Cleveland City Planning Commission

July 24, 2026

Agenda: July 24, 2026

Bicycle Rack
Vestre Forum
Embedded Mount

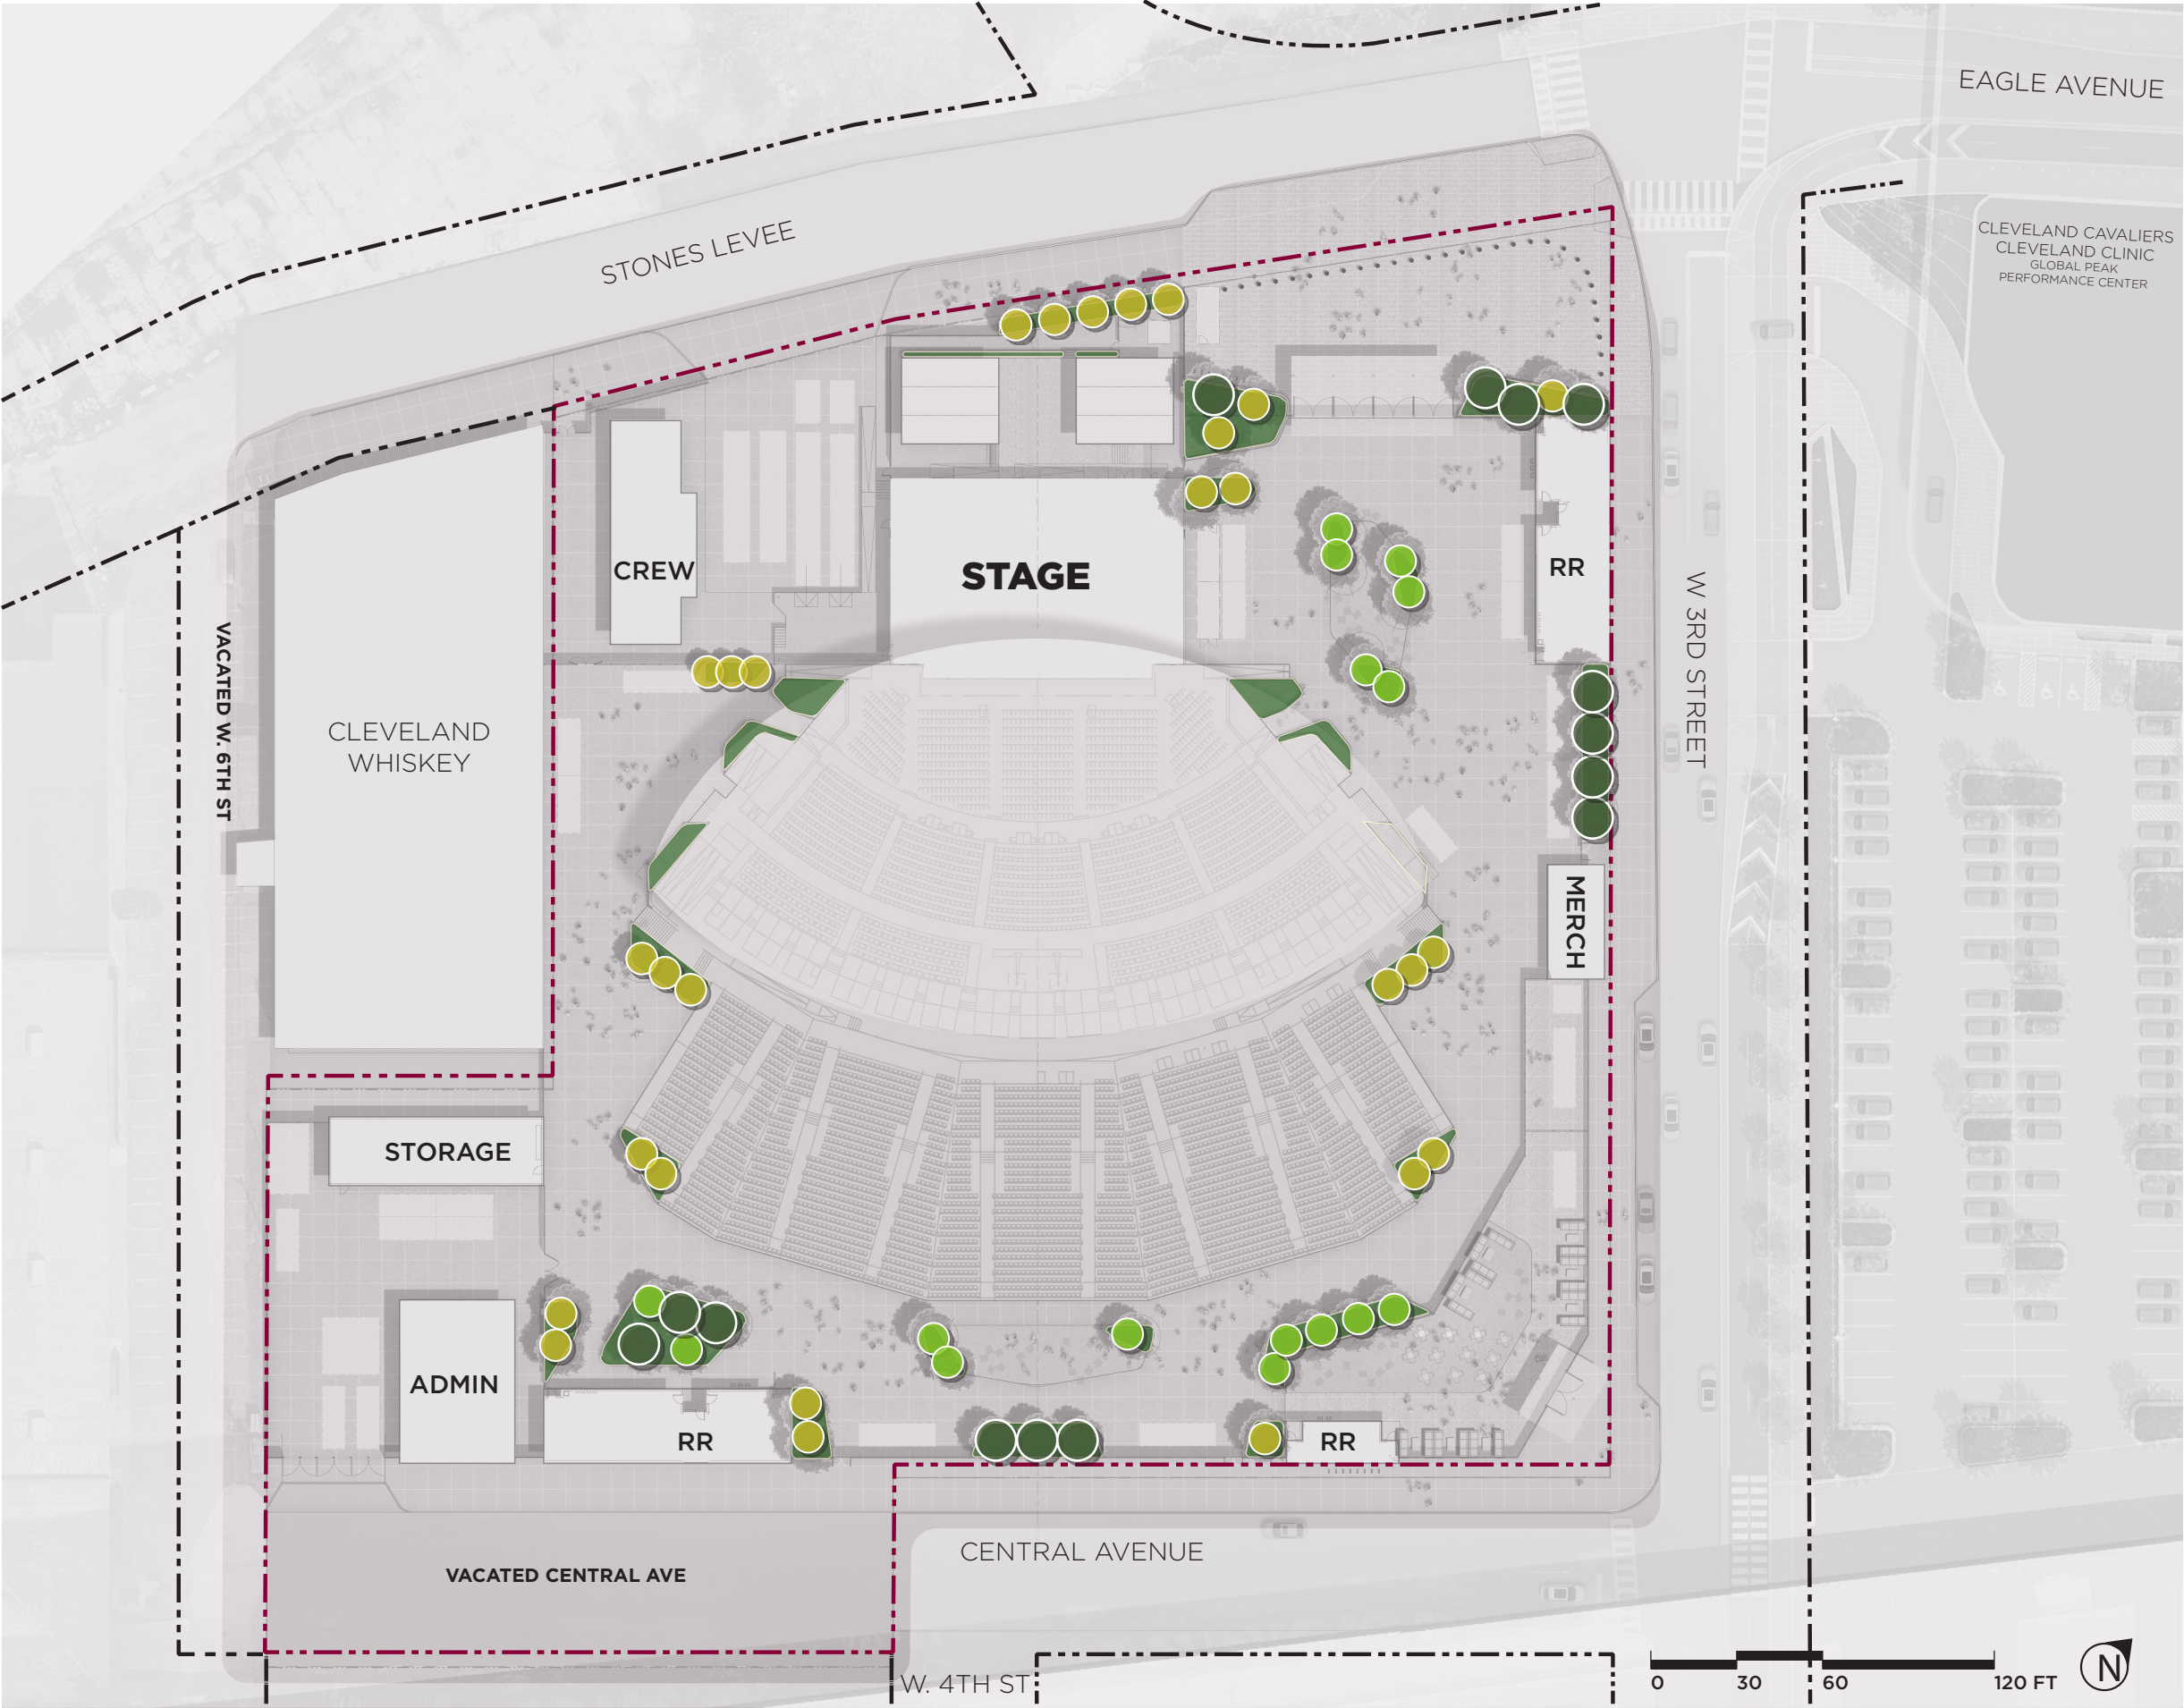
- 1) Provide further **transparency & pedestrian interaction for fencing treatment** at W.3rd St., and reconsider the use of dark metals where there is potential for contact with people [to avoid **burns**].

1. Provide further transparency & pedestrian interaction for fencing treatment at W.3rd St., and reconsider the use of dark metals where there is potential for contact with people [to avoid burns].

Figure 21

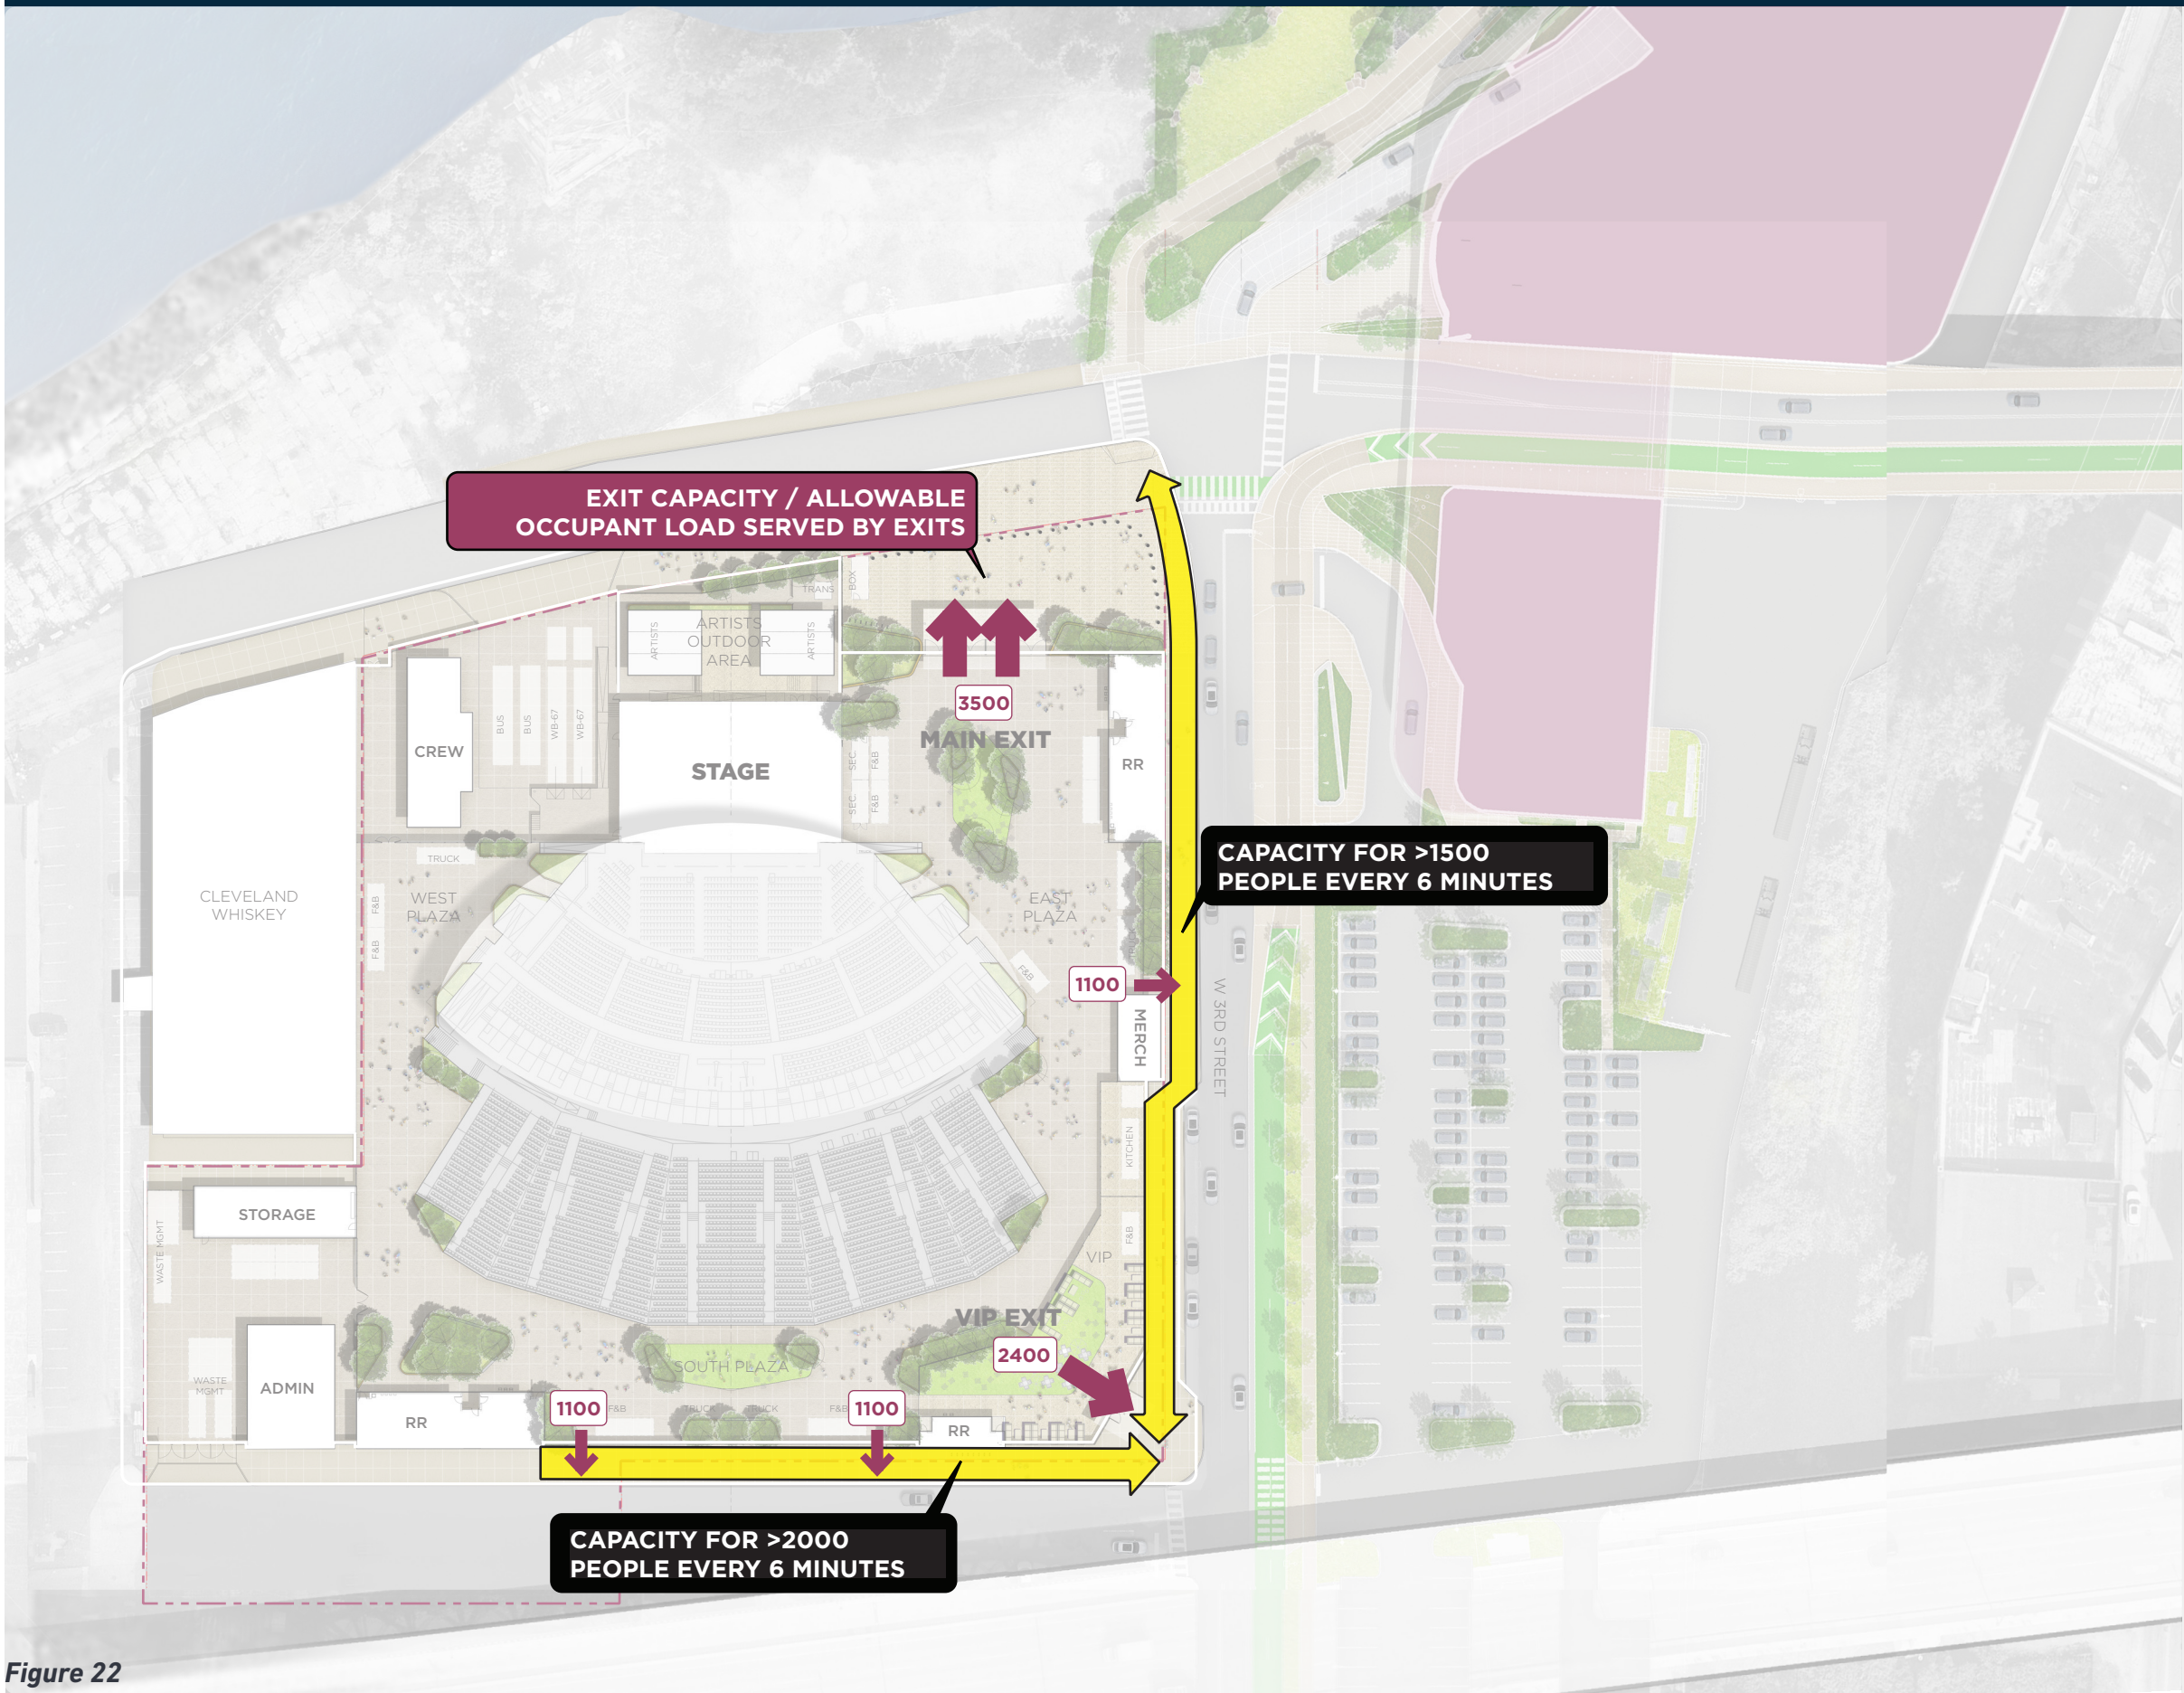
- 4) Further review of the **Transportation Management Plan** and it's successful conclusion [which may indicate the need to shift the project 20' south, or to increase the frontal plaza internally to the site to accommodate queuing].

4. Further review of the Transportation Management Plan and it's successful conclusion [which may indicate the need to shift the project 20' south, or to increase the frontal plaza internally to the site to accommodate queuing].
